Agenda Item:           **Consideration – An Ordinance Approving Final Development Plans and a Final Plat of Subdivision for a ±60 Acre Warehouse/Distribution Development Known as Huntley Commercial Center (former Huntley Outlet Center)**

Petitioner/Owner:    **Huntley Investment Partners, LLC**

BUILDING ELEVATIONS & FINAL SIGNAGE PLAN  
CHI17-0051-00  
05.27.2021

## HUNTLEY, ILLINOIS LANDSCAPE DEVELOPMENT PLANS

**EXISTING CONDITIONS AND DEMOLITION PLAN - SOUTHEAST**

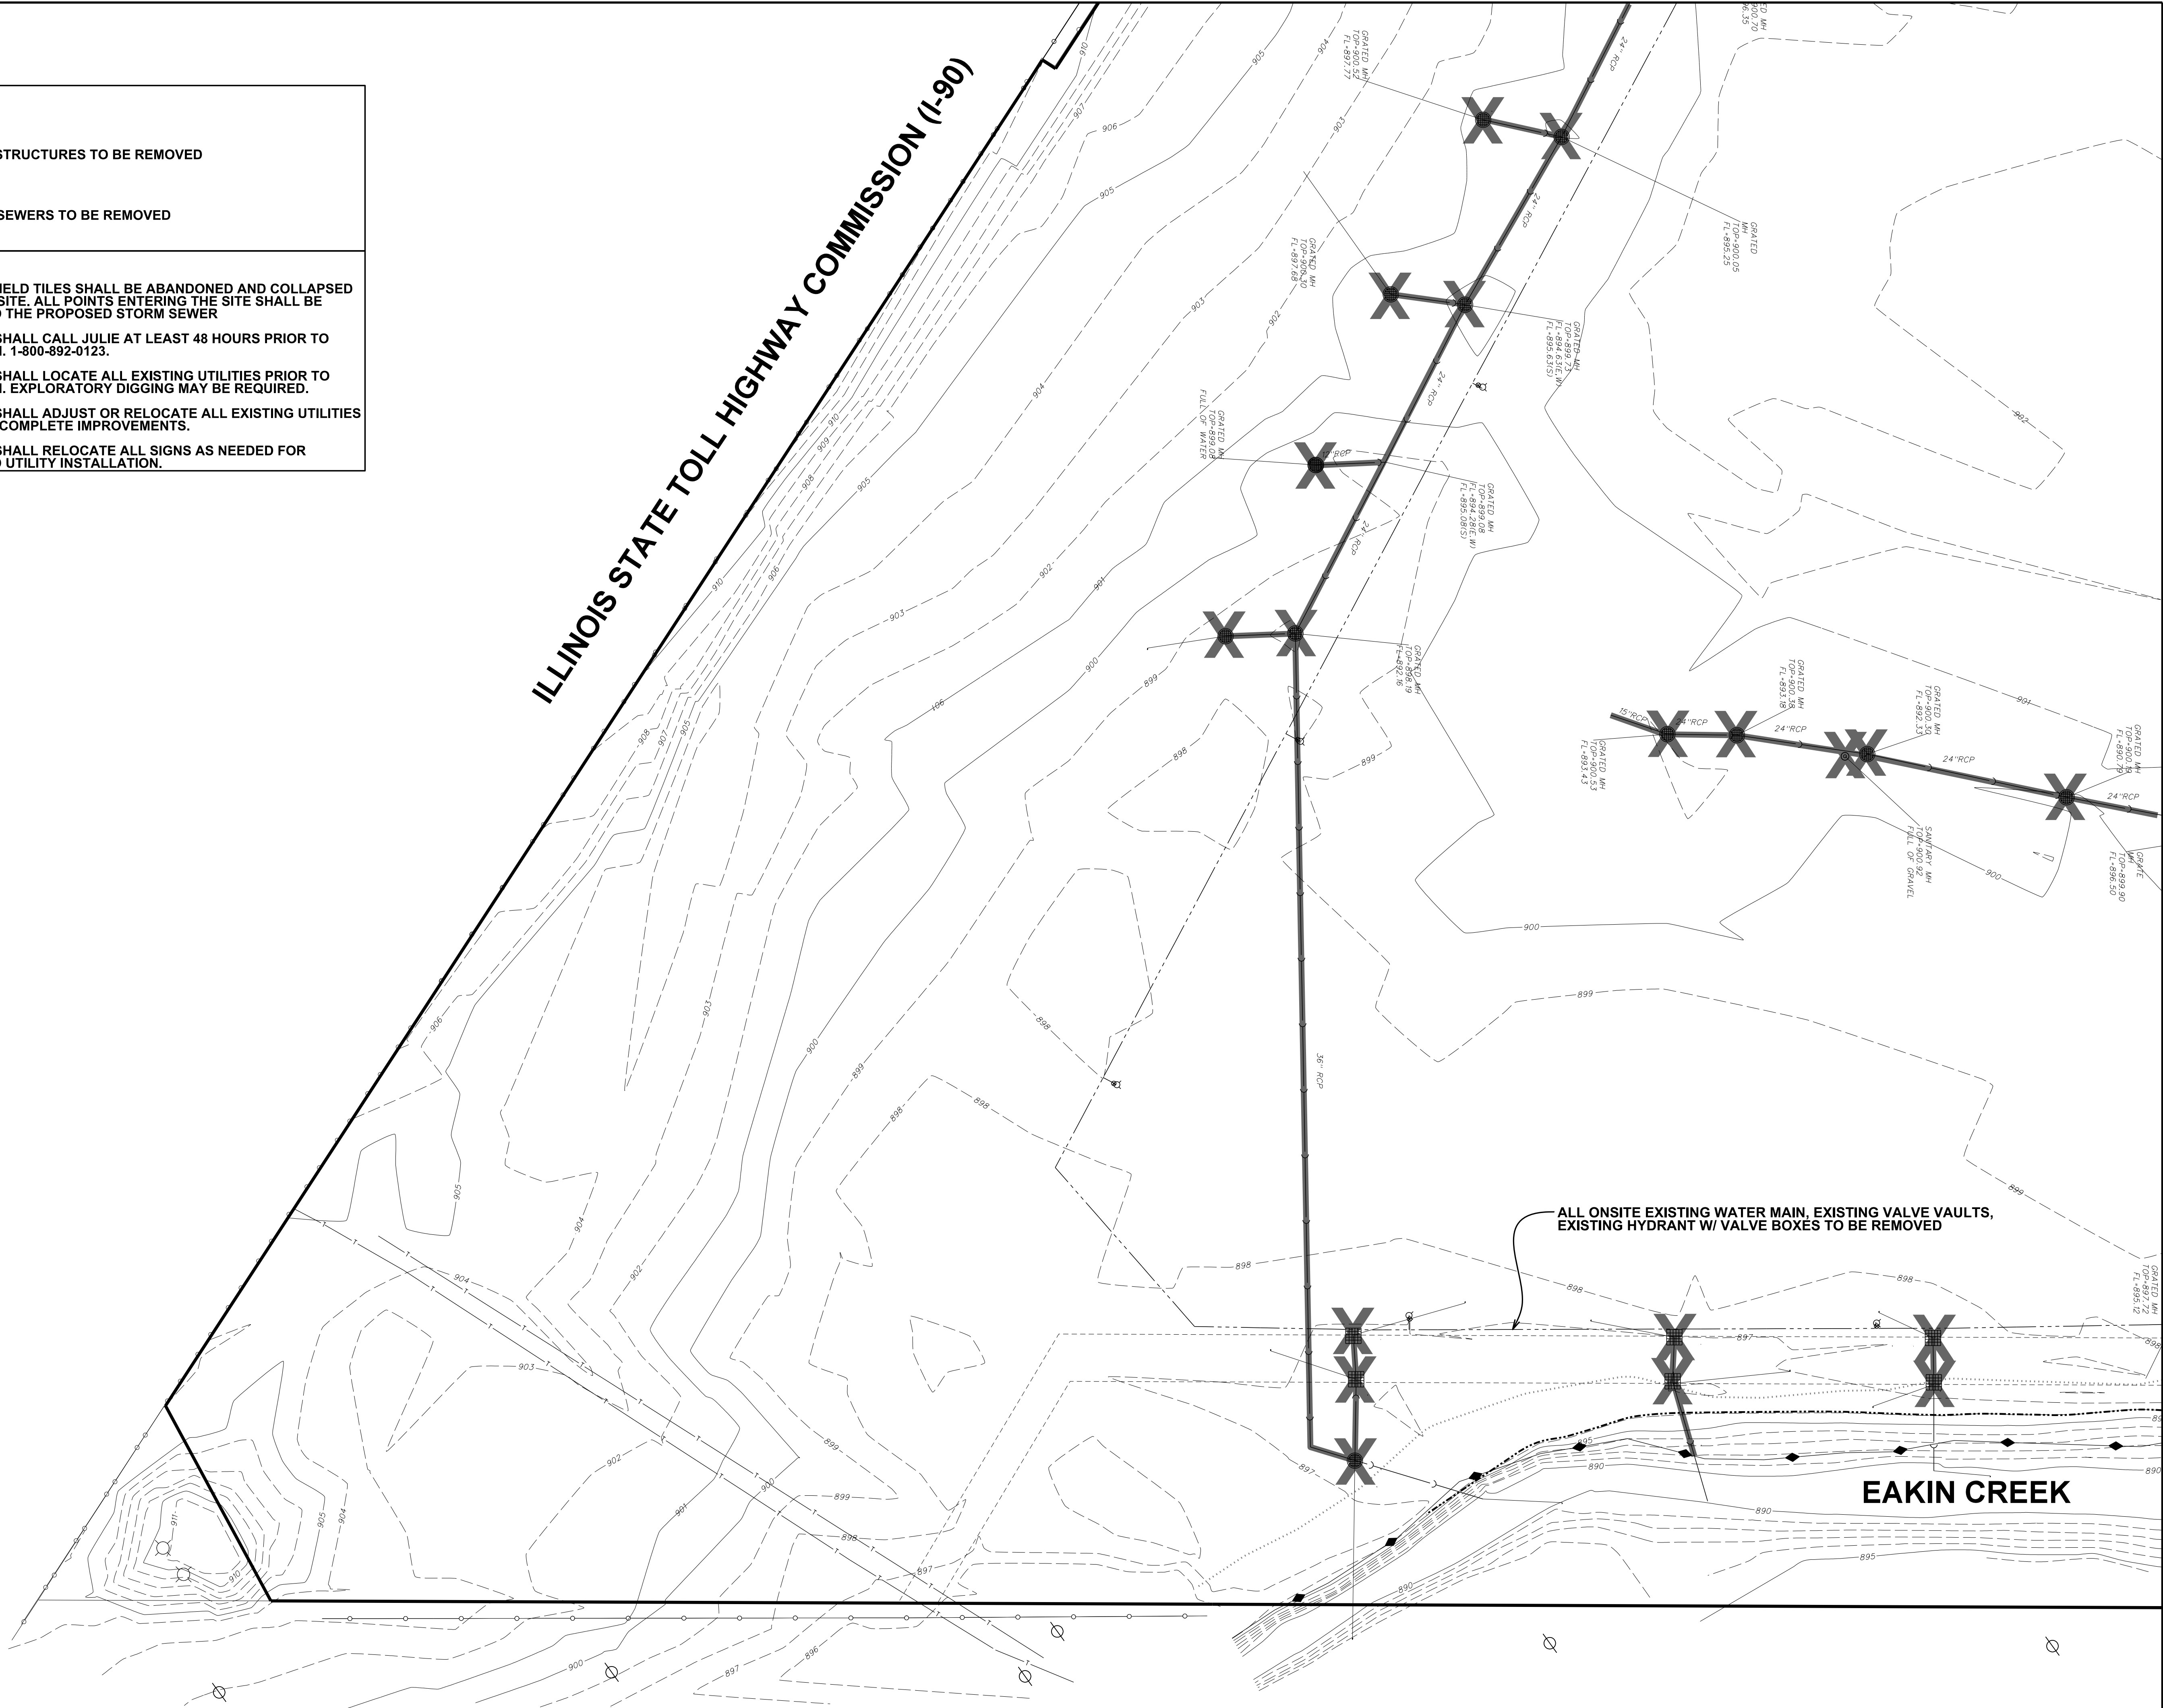
44. The off-site existing watermain and sanitary sewer infrastructure is not shown accurately within the surrounding General RV parcels. The Village will provide the information available in their records to better assist the Engineer. However, the existing infrastructure shall be explored further for potential connections and accurately depicted on the existing conditions/demolition plan sheets. (typical to sheets 6 thru 8)

**EXISTING CONDITIONS AND DEMOLITION PLAN - NORTHEAST**

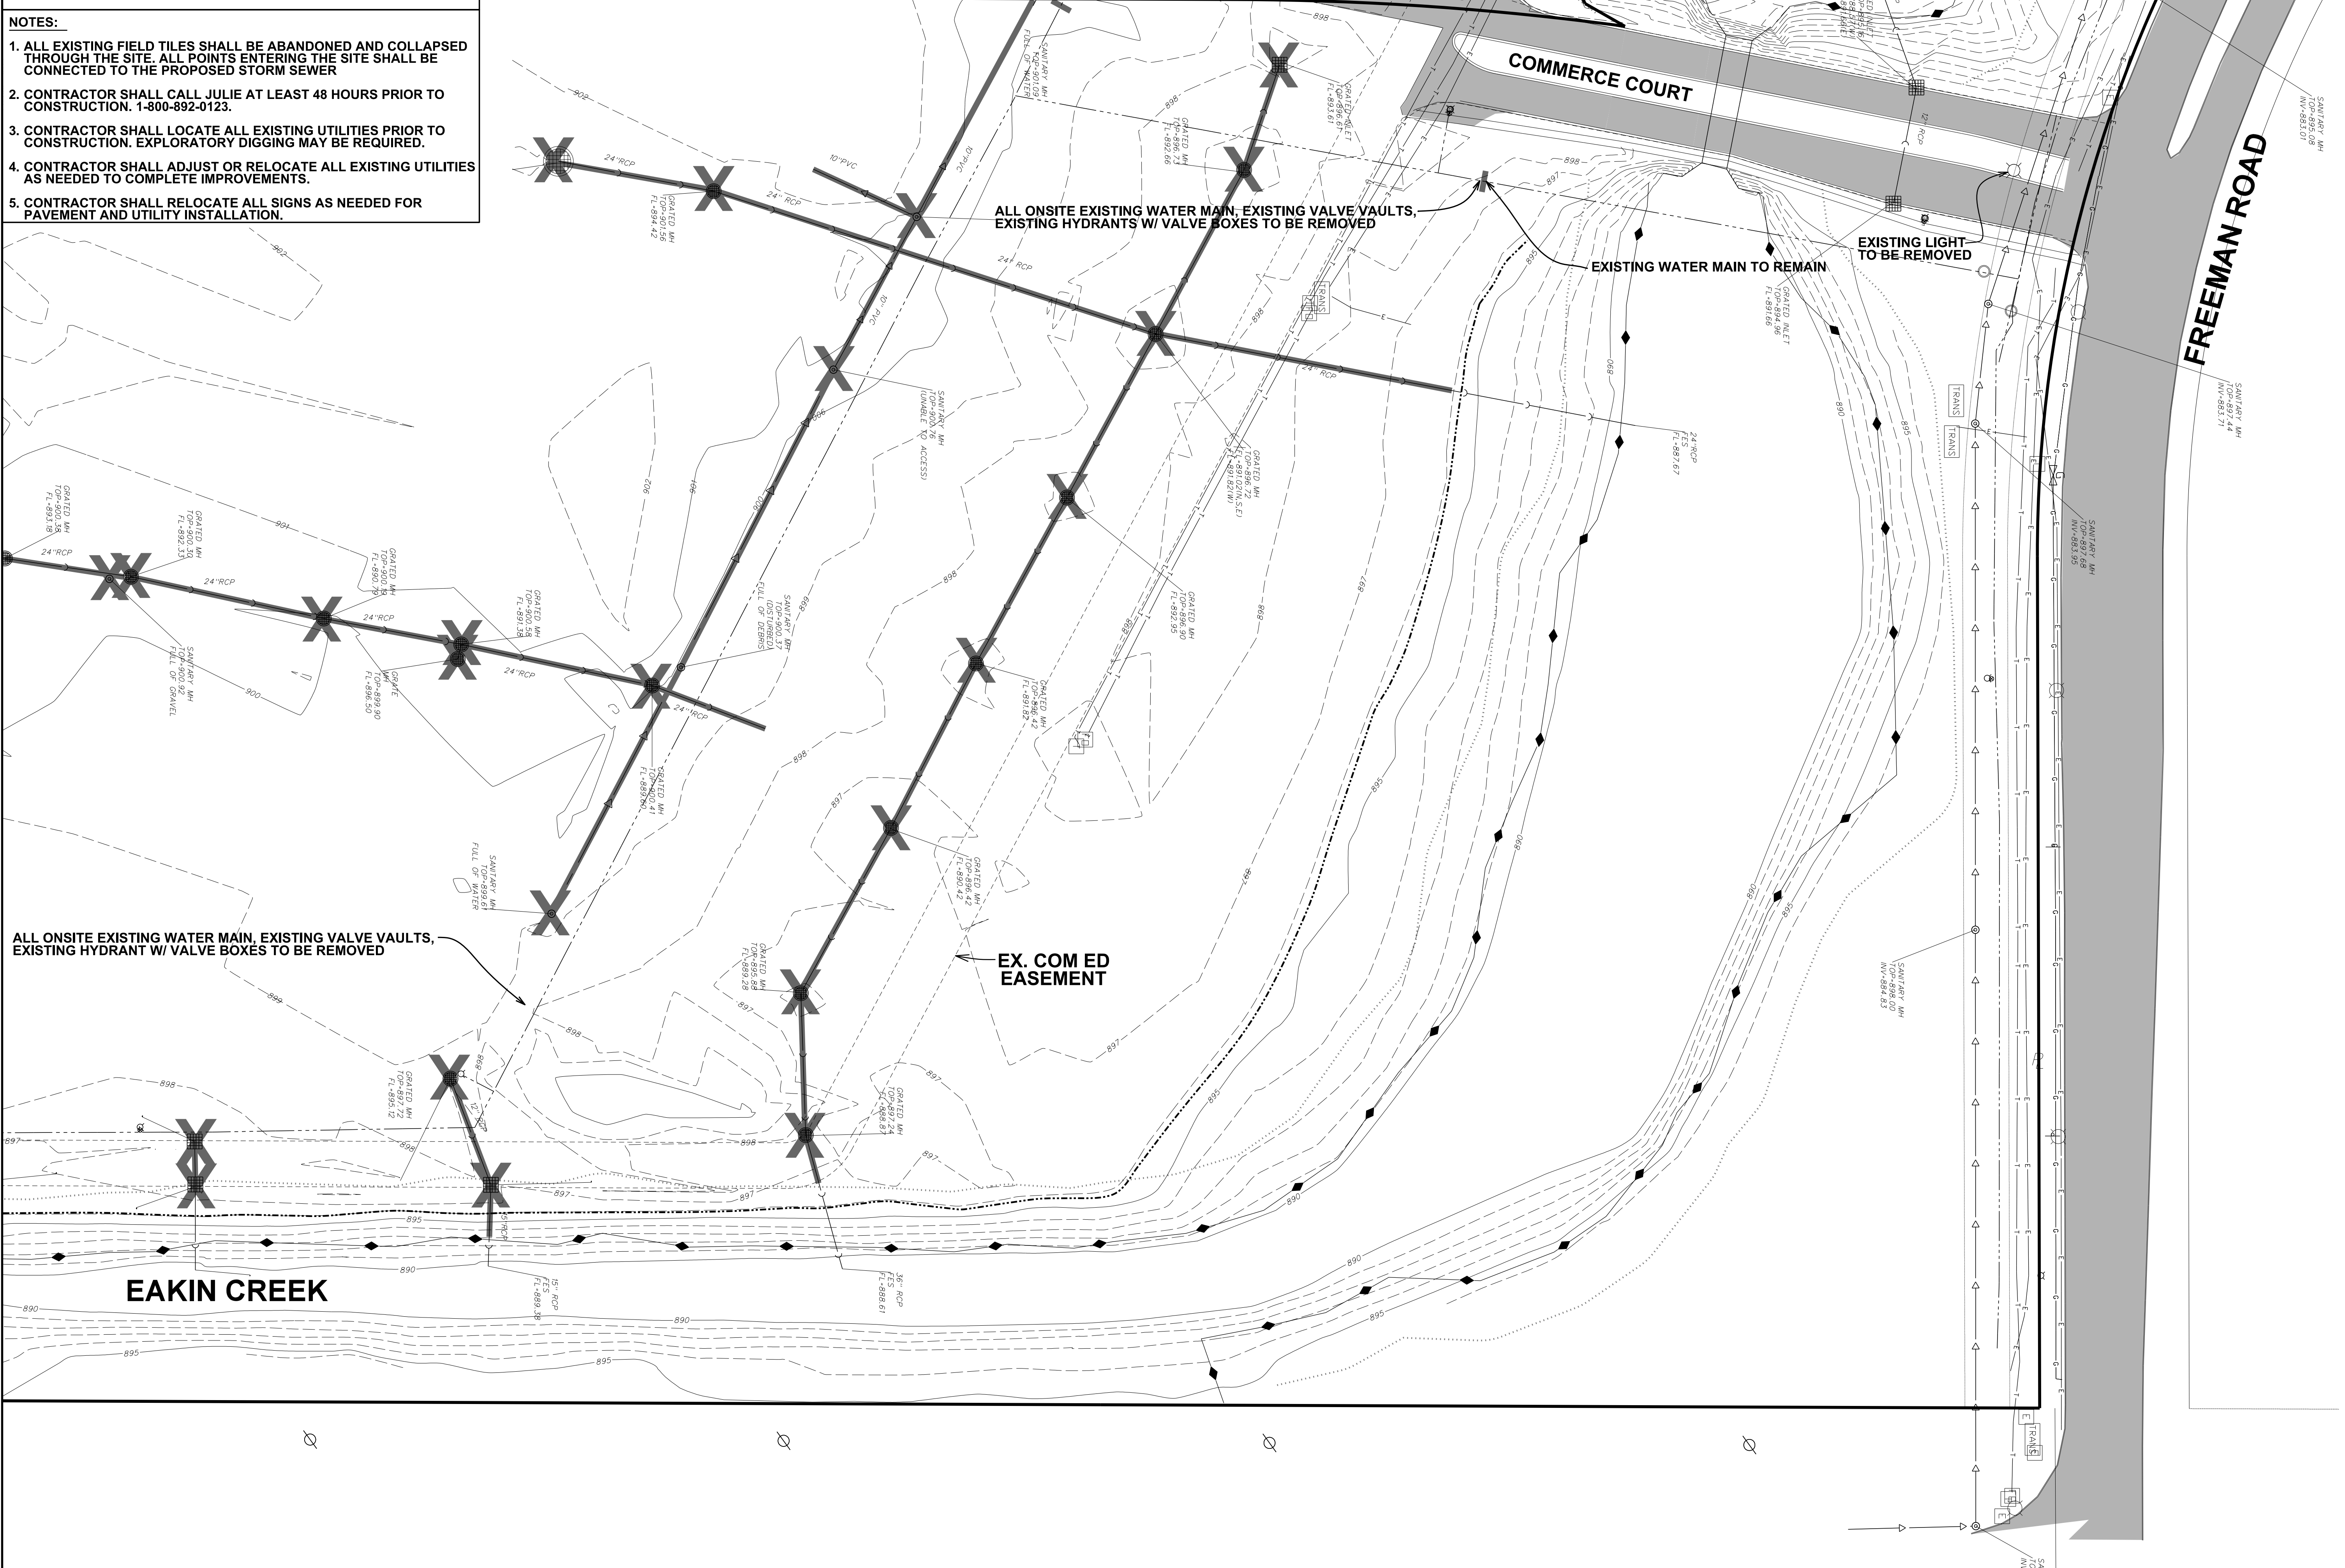
45. The boundaries of the existing Commonwealth Edison easement that bisects proposed lot 2 should be depicted on the plan sheet (typical sheets 7, 10, 13, 16, 19, and 21). It appears that the proposed building on lot 2 could be encroaching into this easement.

**GEOMETRICS PLAN - SOUTHEAST**

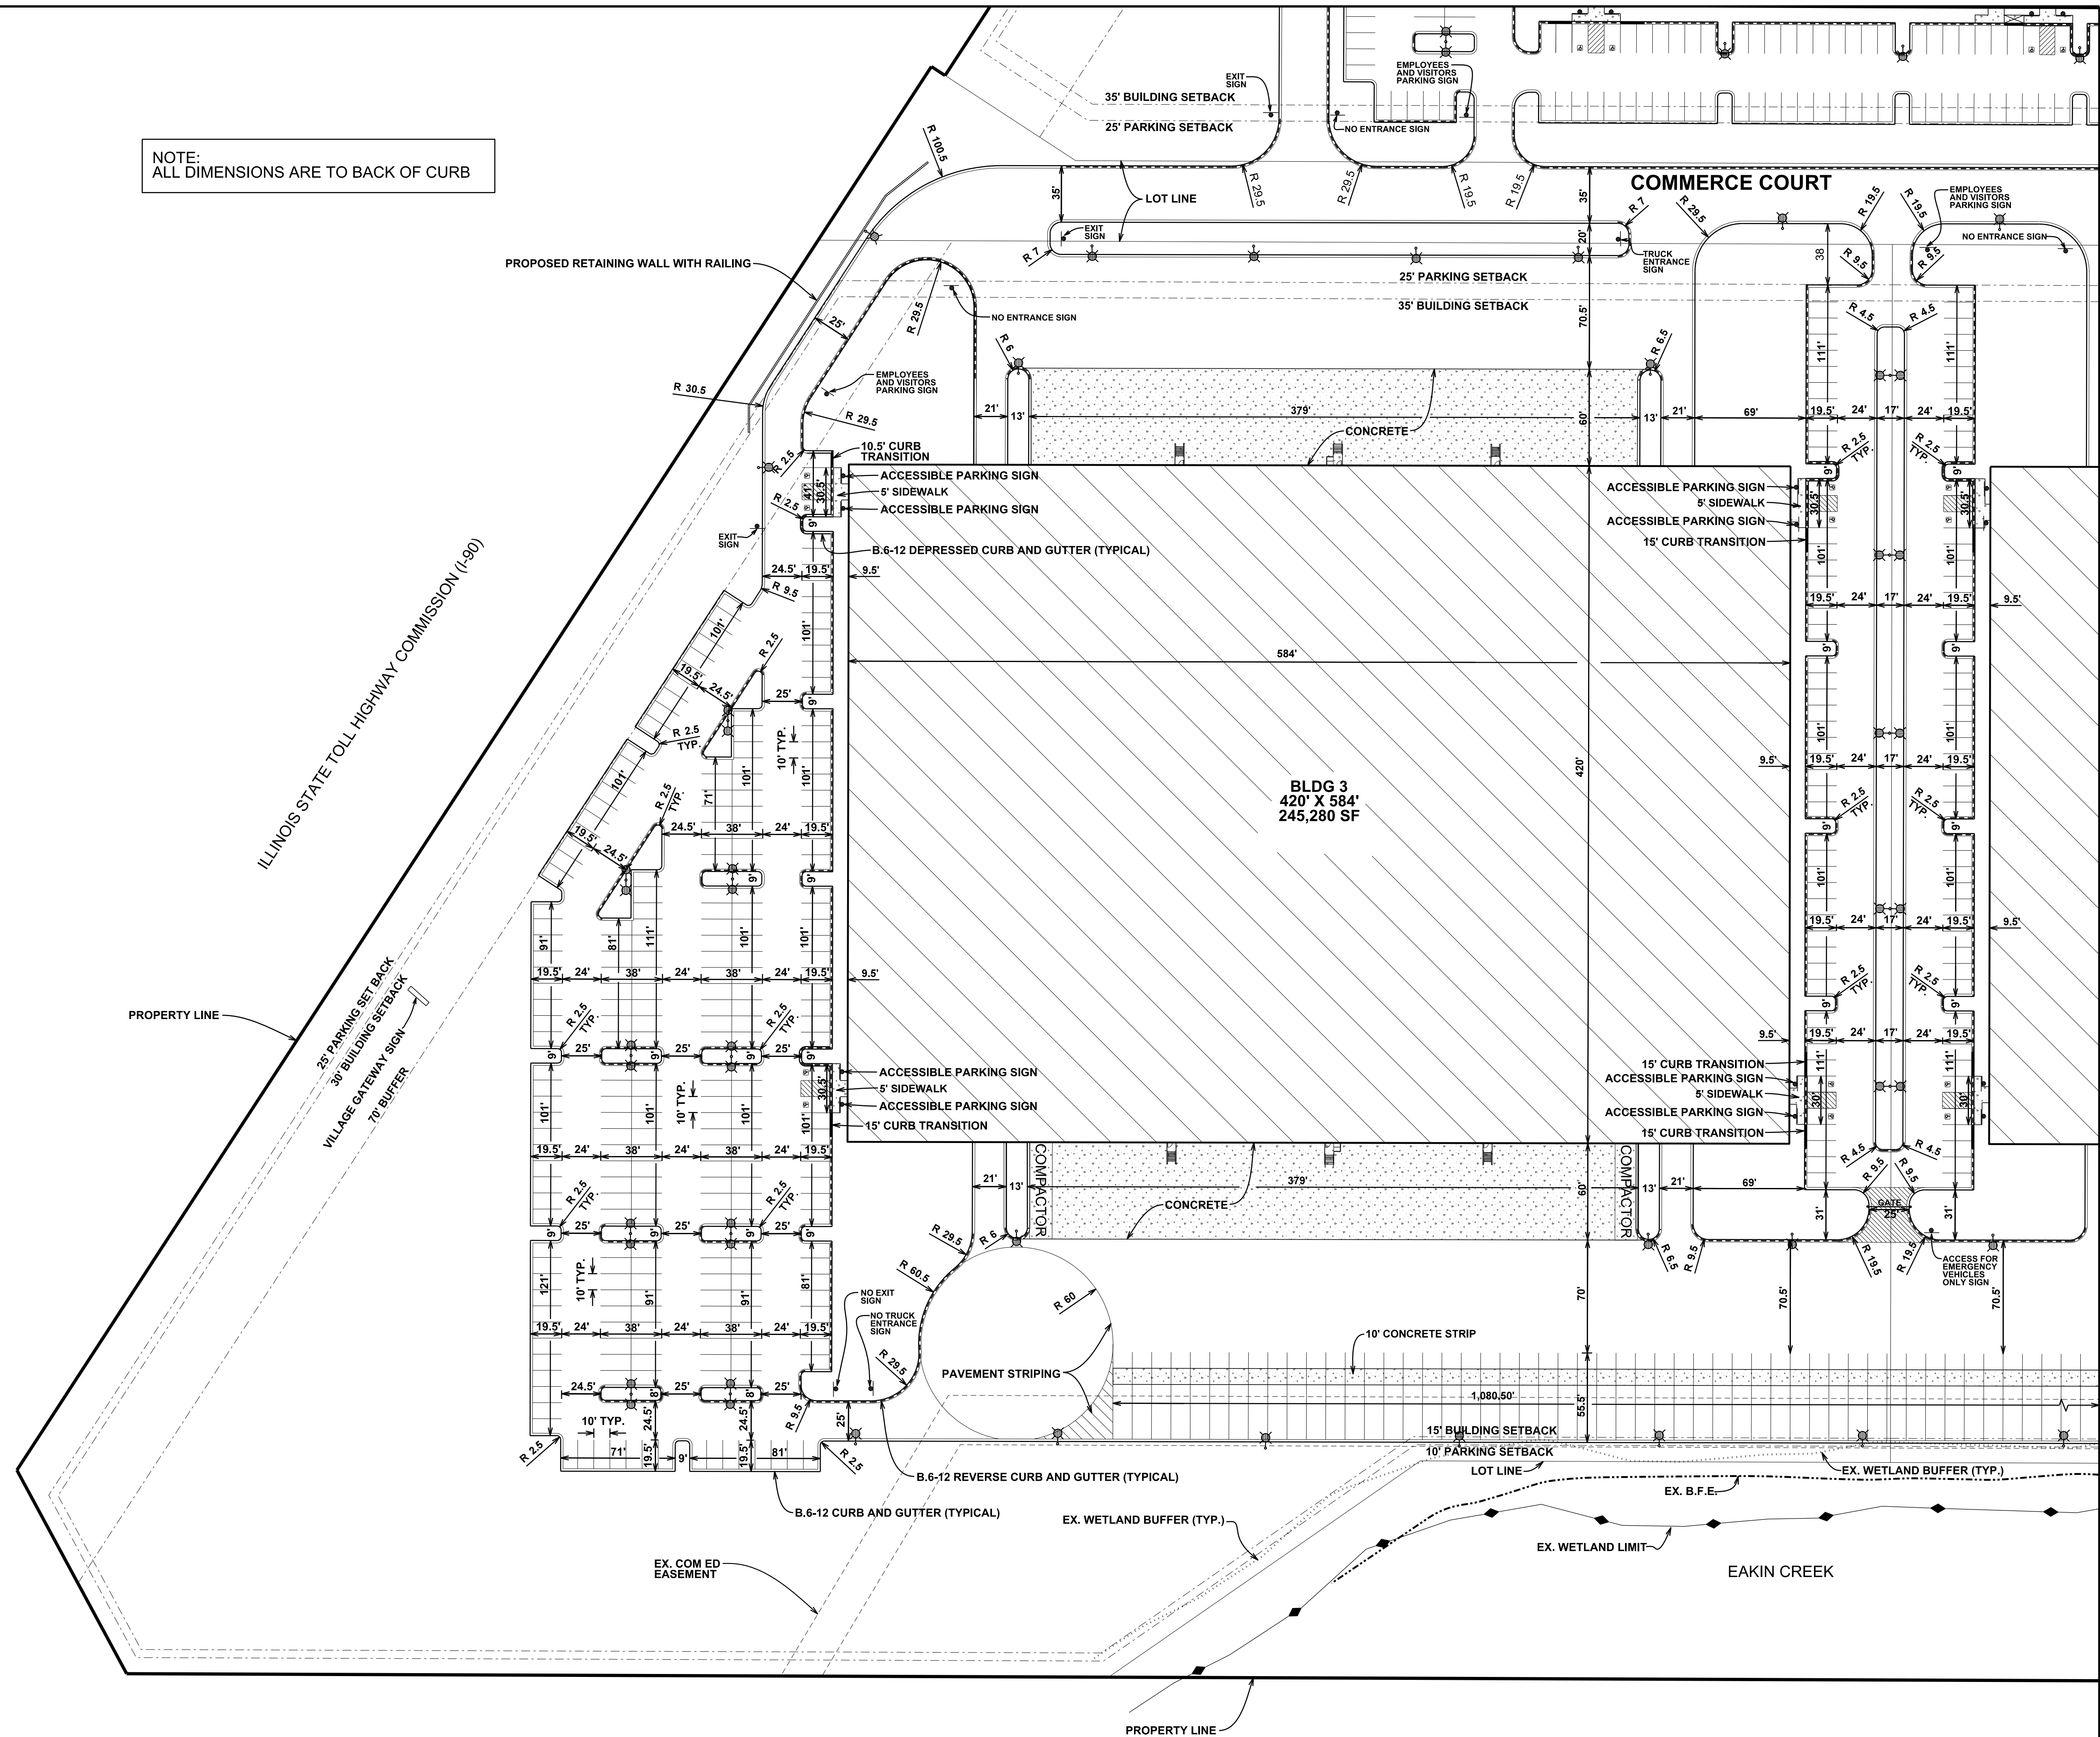
47. The boundaries of the existing wetland, existing wetland buffer, and the existing BFE shall be depicted on the plan sheet (typical to sheets 9 and 10).
